LOT 15B, UNIT 2, ALVARADO GARDENS

ENGINEER'S SEAL	CAMPBELL ESTATES GRADING AND DRAINAGE PLAN	DRAWN BY WCWJ
		DATE 5-25-07
		2712-GR-2-01-07X
DAVID SOULE P.E. #14522	1606 CENTRAL AVENUE SE SUITE 201 ALBUQUERQUE, NM 87106 (505) 872-0999	SHEET # —
		JOB # 2712

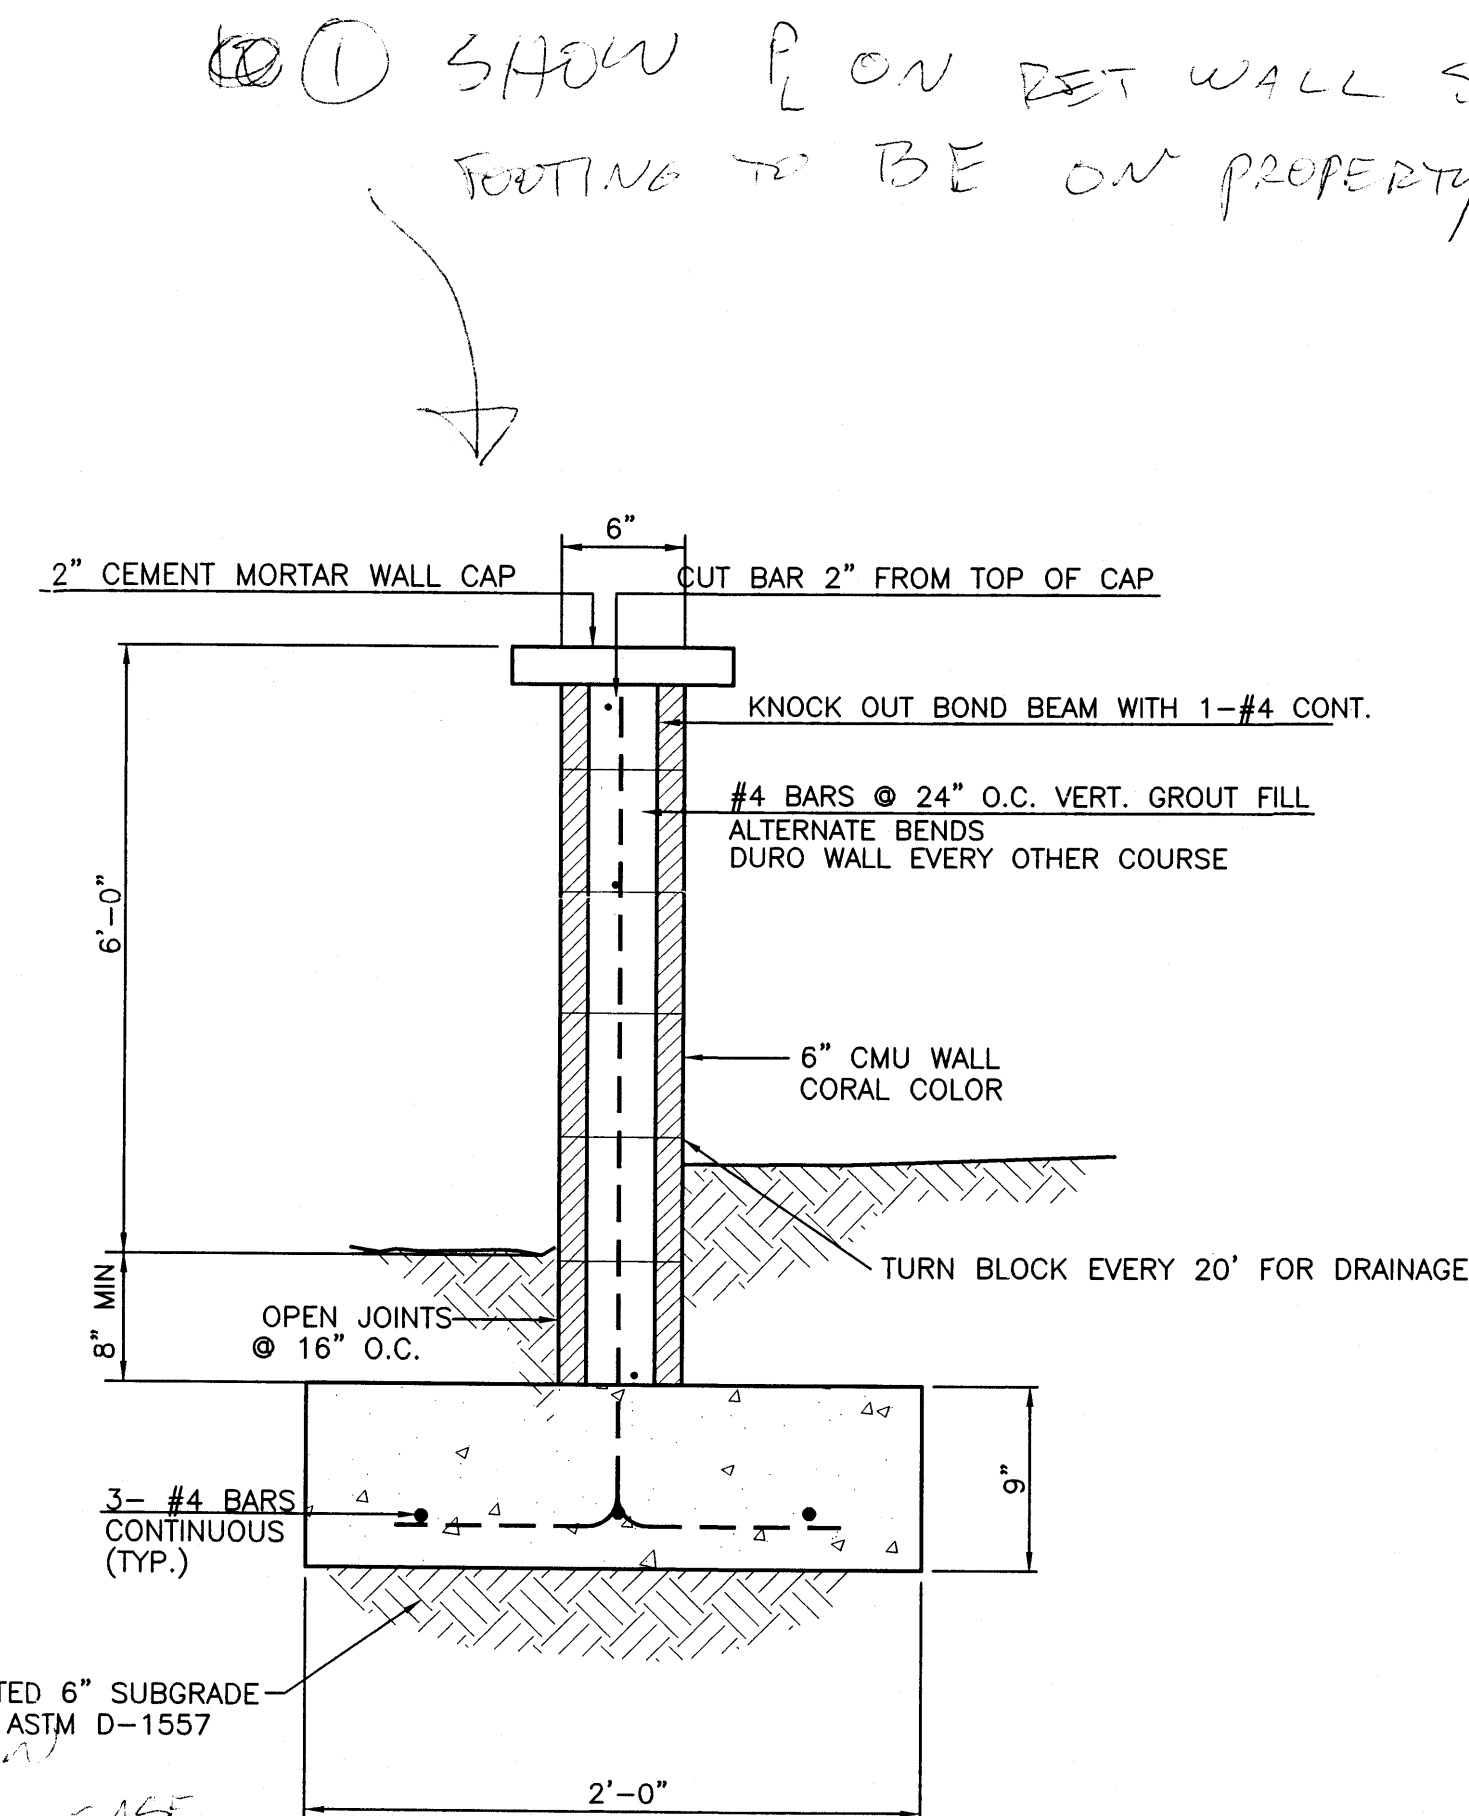
② REDD CALCS W/O ANY 'A'
Stamp + sign CALCS

③ MAX 45% D W/ FLAT GR.
SCHE. INCLUDES REDD
STREET AREA

④ RETENTION NOT DETENTION
SINCE NO CONTROLLED RELEASE

⑤ MAINTAINANCE POND 1 & 2
DIFF LOS. HEA?

⑥ BUILDING SULK IN
CAMPBELL? V.G.?
STD DOWLS

⑦ REVISE DRAINAGE REPORT TO REFLECT
THE CHANGES FROM THE
FPB 2007 RPT
